BARANGAROO SOUTH PUBLIC DOMAIN STAGE 1B

ACCESS REVIEW

FINAL v9

30 April 2019

Figure 3: Not-to-scale extract from drawing BAR-418-DA-WC-DP03

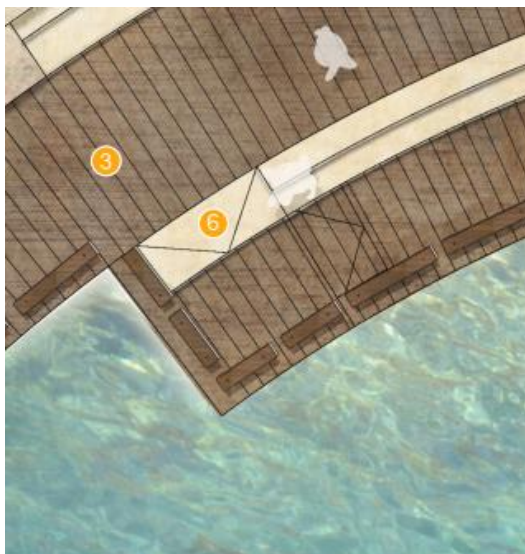
At Watermans Cove, there is an arced lower deck at the timber boardwalk at the water's edge. The January 2017 design contained only stair access to the lower deck.

By contrast, the November 2017 design incorporates pedestrian ramps to the lower deck, as shown in Figure 3 below:

The provision of step-free access to the lower deck is a positive amendment. Care will be required that the ramps will be detailed to be accessible for as many users as possible.

Figure 4: Not-to-scale extract from drawing BAR-418-DA-WC-PL01

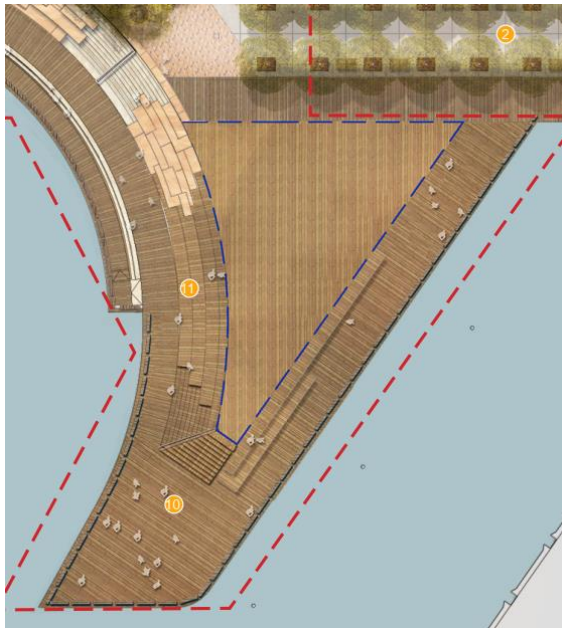
There is a designated site for a future community building at the southern end of Watermans Cove. The site is indicated in plan via the blue dashed line in the Figure 4 below:

The finished flooring of the site of the future community building is located on-grade with the main promenade of Wulugul Walk at the eastern edge of the site. There will be stairway access and bleacher seating at the northern edge of the site.

There would be two broad accessibility issues in relation to the site of the future community building. The first issue is the intended use of the site prior to the construction of the community building. The November 2017 design of the public domain strongly implies that the site will be a flat, open-plan deck, with no permanent vegetation or fixed furniture.

The provision of access for people with a disability from the adjacent boardwalks to and within the site would be achievable. A flat, open-plan deck will also be capable of providing accessible paths of travel for people with a disability to potential short-term attractions and features that could, from time to time, be installed there, such as art displays or market stalls.

The second issue is the design of the community building itself. If and when the community building is designed and built, the building will be expected to comply with the minimum accessibility requirements of the DDA Premises Standards 2010 and the BCA. Those requirements will include, at minimum, the provision of access for people with a disability to the main entrances of the building.

This gives rise to two competing possibilities. On the one hand, the *de facto* access arrangements to the site could act as a constraint on the design of the community building. For example, the public domain design currently provides on-grade access to the site from the east. Given this, the main entrance to the community building may

need to be located on the eastern side of the site in order for the building to achieve compliance with the DDA Access Code 2010 / BCA.

On the other hand, the designers of the community building may choose to designate the accessible main entrance at an area which, in the present public domain works, is *not* accessible for people with a disability. In that case, the public domain may need to be modified at that time in order for the building to be appropriately accessible under code.

Figure 5: Not-to-scale extract from drawing B1B-L-D-2-00-14-3114 -04.

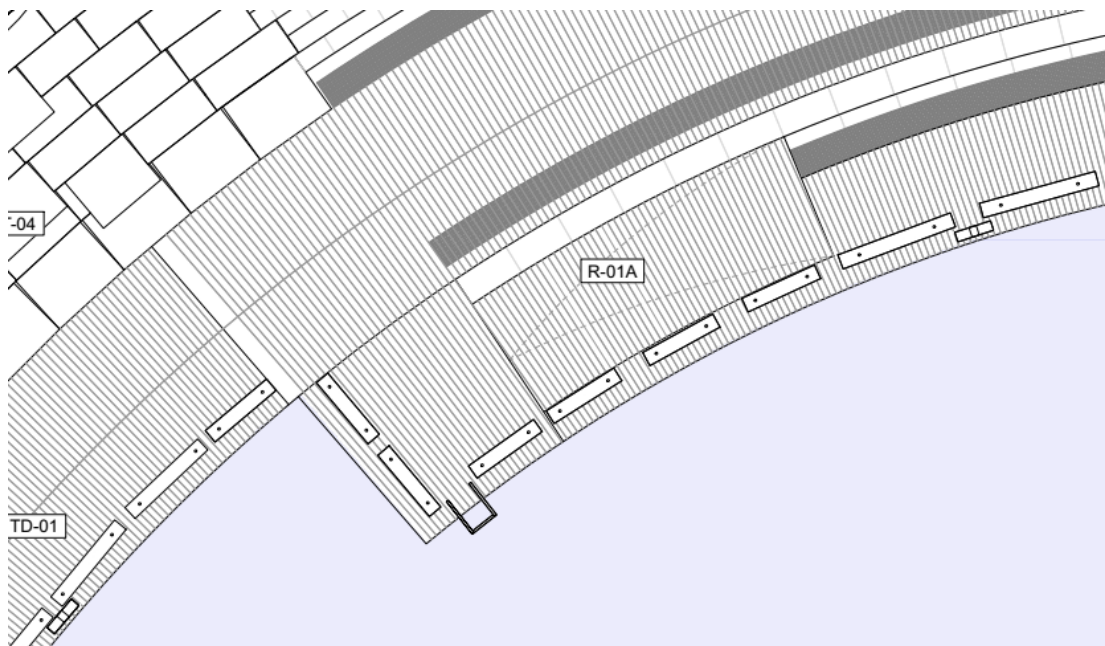
At Watermans Cove, there is an arced lower deck at the timber boardwalk at the water's edge. The design at November 2017 included pedestrian ramps to the lower deck at the northern and southern ends respectively.

In the updated design at 22 March 2019, both of those ramps have been significantly reconfigured. At the northern end, there is a new graded walkway with a gradient of 1 in 20 that runs to the lower arced deck. The above graded walkway is shown in plan in Figure 5 below:

The gradients and clearances at each of the above walkways will be capable of providing equitable access within the meaning of AS1428.1(2009) to the lower deck for both wheelchair users and people with a mobility impairment.

The gradients and setouts of the ramps as at November 2017 contained specific weaknesses for access especially for people in wheelchairs. By comparison, the configuration current to 22 March 2019 represents a substantial improvement to access as compared to the previous setout.

Consideration will be given when detailing the new setout for the design of any diminishing risers at both the northern and southern ends to suitably cater for people with a vision impairment.

Figure 7: Not-to-scale extract from drawing B1B-L-D-0-00-00-0006-04 showing plan of the new pier setout.

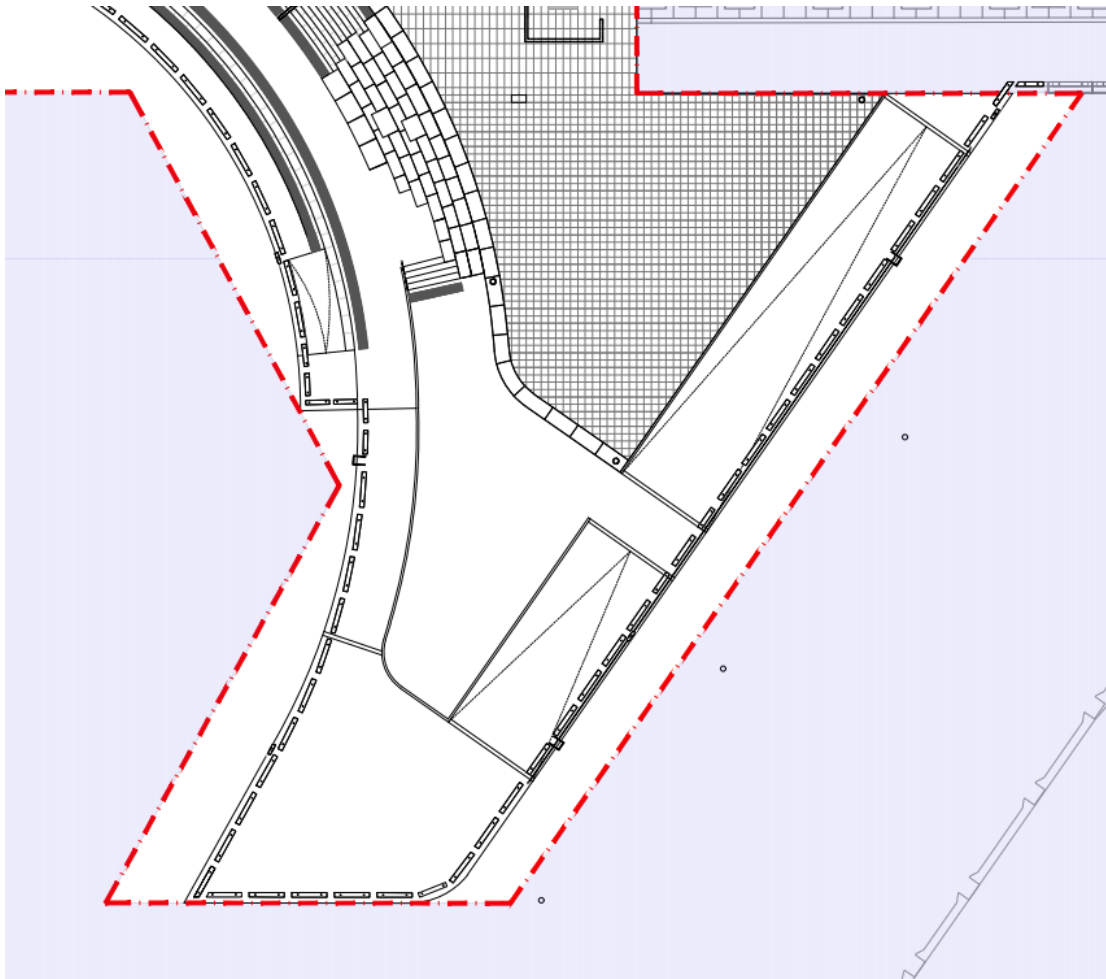
The design current to 22 March 2019 will include an open, public-use platform at FFL3.325. There will be on-grade accessible paths of travel from Wulugul Walk to the above platform. This is broadly consistent with the design at November 2017.

The design current to March 2019 also includes a separate open, public-use platform at FFL2.60. There will be an accessible path of travel to the above platform via graded timber walkways. The graded walkways themselves will have gradients and clearances that will meet AS1428.1(2009).

The graded walkways will directly abut the level platforms. Consideration will be given during the design development phase to address potential trip hazards at the interfaces between the graded walkways and the level platforms.

The design current to 22 March 2019 will finally also include a new stairway that will run from the main waterside timber boardwalk at FFL1.80 up to the new platform at FFL2.60. The above stairway will be appropriately detailed to cater for people with a disability.
